PLANNING DEPARTMENT
Staff Report & Recommendation

Design Review Board

SUBJECT: DRB24-1014
4-6 Star Island

The applicant has submitted plans entitled "4, 5, & 6 Star Island Drive" as designed by **Domo Architecture + Design**, dated 4/7/2024.

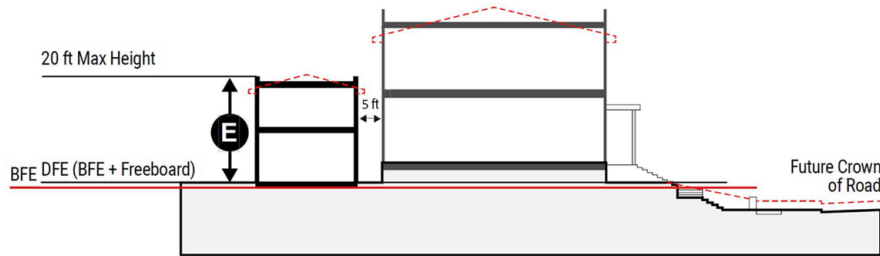
The Applicant is requesting a five (5) foot height variance for the one-story cabana accessory structure at the rear yard. The cabana is proposed at a height of 17 feet and 9" which exceeds the maximum height of 12' for a one-story accessory structure. It is important to note that for accessory structures, the height is measured from base flood elevation plus one foot of freeboard. When facing a waterway, the minimum setback for a one-story accessory structure is one half of the required rear setback. In contrast, the minimum required setback for a two-story accessory structure along an interior side yard is 10 feet or the required side yard setback. The rear setback for a two-story accessory structure consists of one half of the required rear setback or 15', whichever is greater.

Staff is supportive of the height variance due to the proposed accessory structure complying with the greater setback requirements of a two-story structure. The lush landscaping along the side yard is set partially on a lower terrace than the pool and therefore minimizing the height in relation to the pool. Consequently, the granting of the variance requested will not confer on the applicant any special privilege that is denied by these land development regulations to other lands, buildings, or structures in the same zoning district. While staff has no objection to the granting of the proposed variance, pursuant to Article I, Section 2 of the Related Special Acts, the maximum height variance that can be approved by the board is three (3) feet. As such, staff recommends that the variance be approved, not to exceed 3 feet.
